Application	General Data	
Project Name: Cameron Park	PC Hearing:	May 6, 2014
	CC Hearing:	May 17, 2014
	If approved, DSUP Expiration:	May 17, 2017 (36 months)
	Plan Acreage:	7.80 acres or 339,667 sq. ft.
Location: 430 and 450 South Pickett Street	Zone:	CSL existing, CDD proposed
	Proposed Use:	Mixed-Use
	Dwelling Units:	Approximately 457
	Gross Floor Area:	722,223 sq. ft.
Applicant: JBG Cameron Park, LLC and Pulte Homes represented by Ken Wire	Corridor Plan:	Landmark/Van Dorn
	Historic District:	Not applicable
	Green Building:	LEED Silver for Nonresidential, LEED Certified for Residential

Purpose of Application
The applicant requests approval of a Master Plan Amendment, Rezoning/Map Amendment, and Development Special Use Permit with Site Plan with modifications to construct an approximately 722,223 gross square feet of development to include two mixed-use multi-family buildings with structured parking, and 66 townhomes.
Special Use Permits and Modifications Requested:
<ol style="list-style-type: none"> 1. An amendment to the Landmark Van Dorn Corridor Plan chapter of the Master Plan for a height increase. 2. Rezoning from Commercial Service Low (CSL) to Coordinated Development Dis

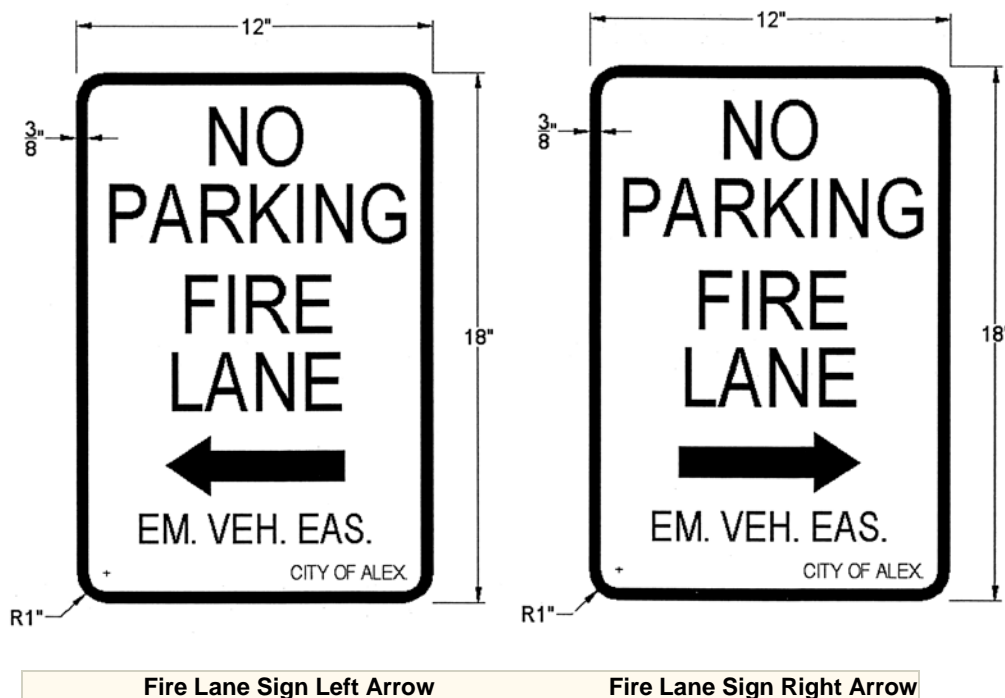
- C-8 The final site plans shall show placement of emergency vehicle easement signs. See sign detail and placement requirements below.

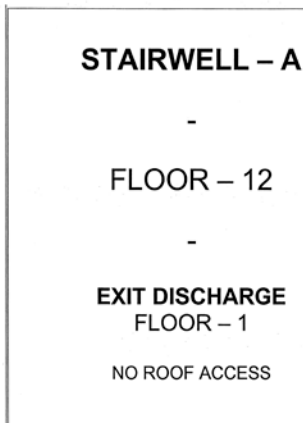
Applicant has provided requested information. However, the turning radius demonstrated on the plans is too tight and will cause access problems for the fire department.
